# CITY OF ALBUQUERQUE

**Re: Smiles for Kids Dental Office  
Conceptual DMP and Conceptual Grading Plan  
Engineer's Stamp Date -no stamp- (C12D054)**

Re: Smiles for Kids Dental Office, Hydrology Re-Submittal

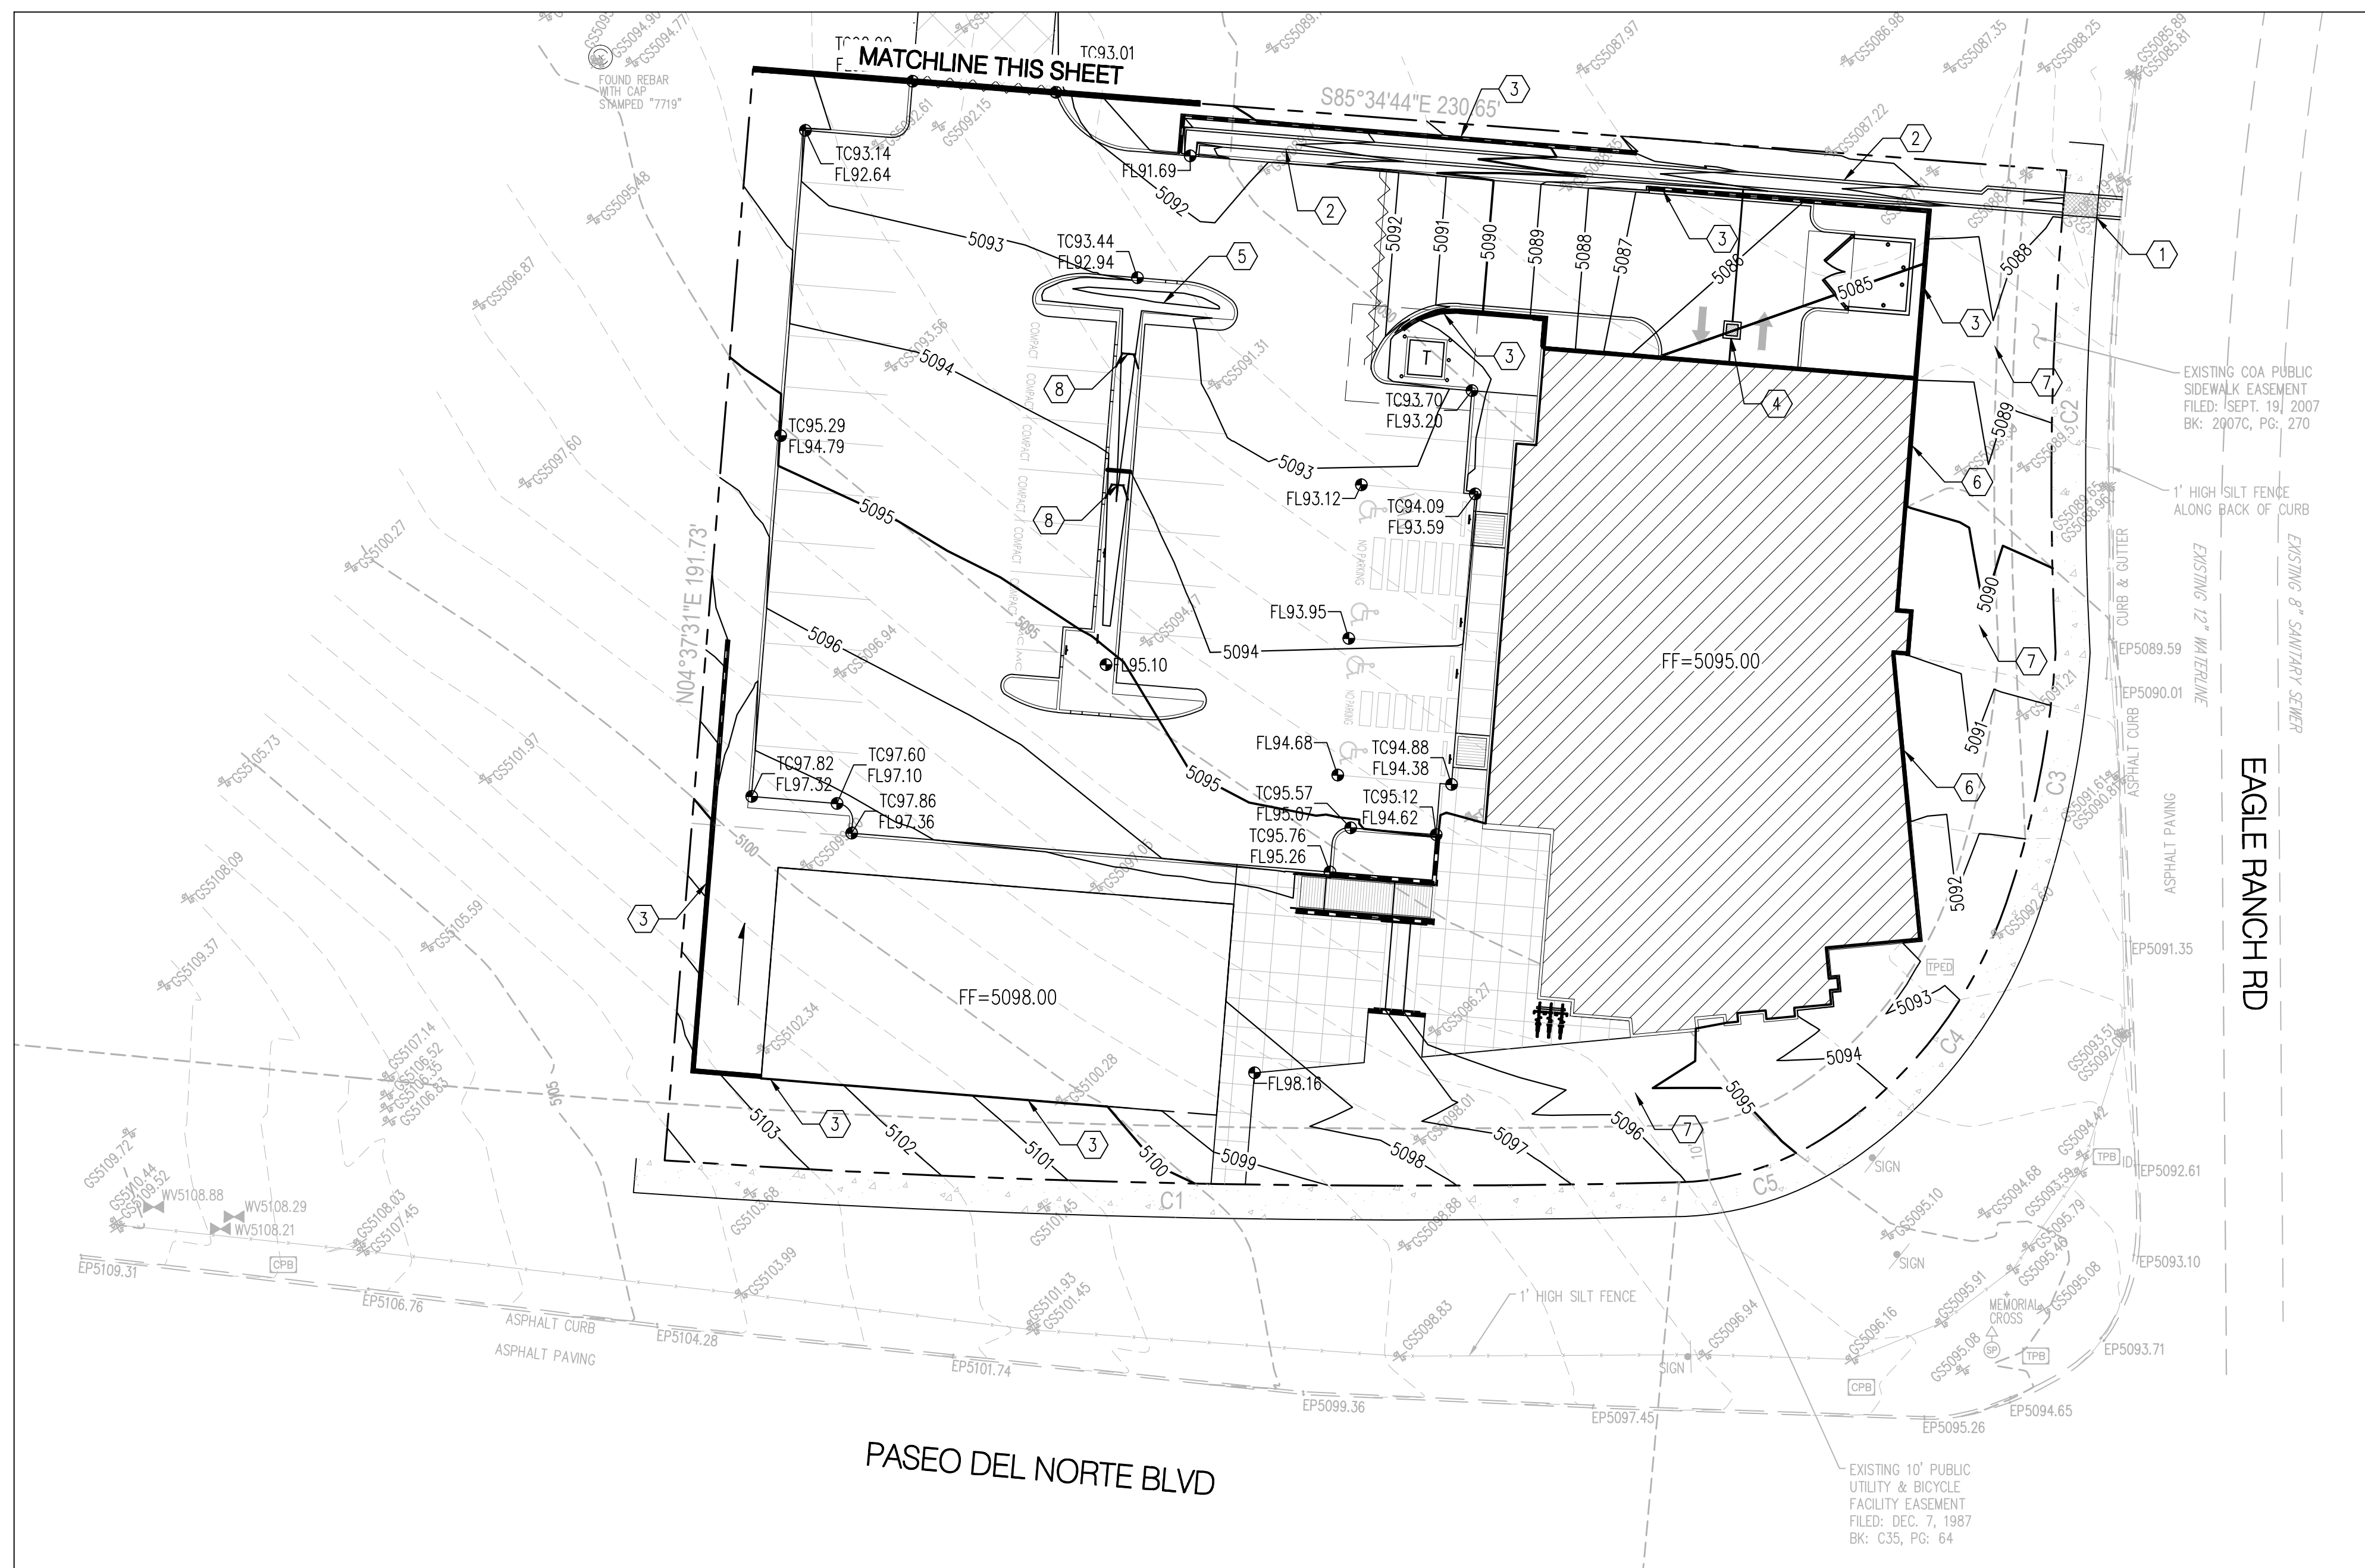
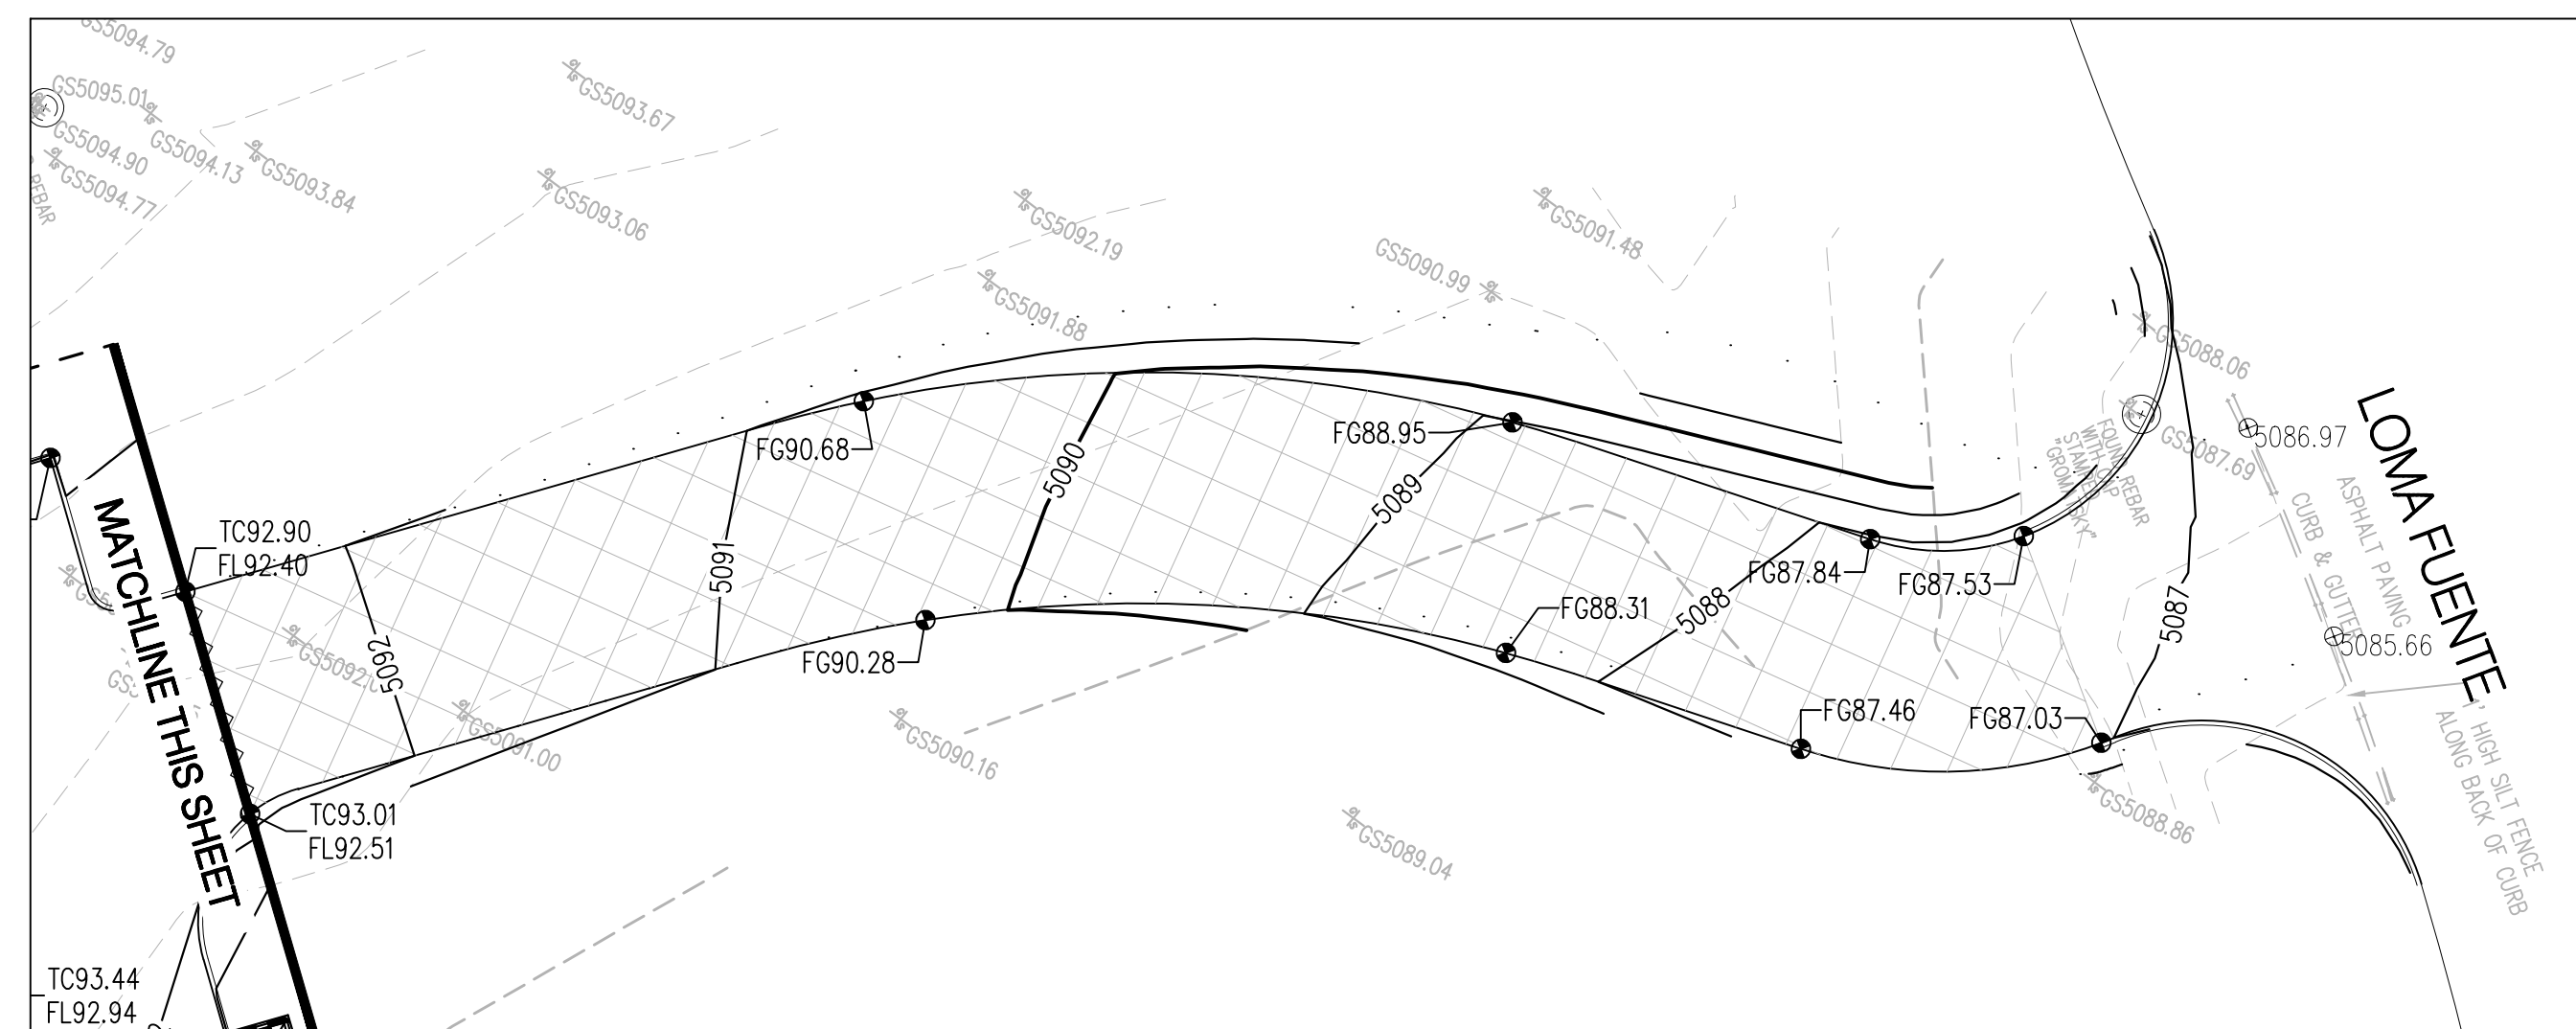
1. The first flush pond was relocated to the parking lot as discussed. Due to site constraints such as building and parking setbacks, site steepness, and an existing utility easement, the pond volume provided does not entirely satisfy the first flush requirements.
2. The retaining wall running adjacent to the ribbon channel along the North property line, doesn't allow enough space for an effective first flush pond.
3. The first flush volume calculations are provided in the drainage narrative on the updated DMP.
